BEFORE THE BOARD OF PATENT APPEALS
AND INTERFERENCES

Application Number: 09/810,943
Filing Date: March 16, 2001
Appellant(s): OESTREICHER ET AL.

EXAMINER'S ANSWER

Figure 1

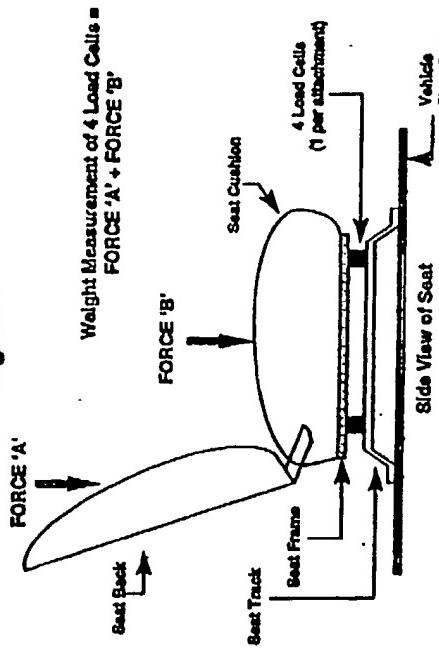
2. With respect to claim 36, the Research disclose teaches a seat frame, four load cells are attached between the seat frame and the seat track at the mounting points (see figure 1), and a vehicle occupant protection device responsive to the output of the load cells (see figure 2).

5. With respect to claim 38, The Research disclosure does disclose a deflectable seat cushion on the frame (see figure 1).

6. With respect to claim 39, the Research disclosure does disclose the vehicle seat frame having a bottom portion and a back portion which together bear a vehicle occupant weight load (figure 1, forces A and B).
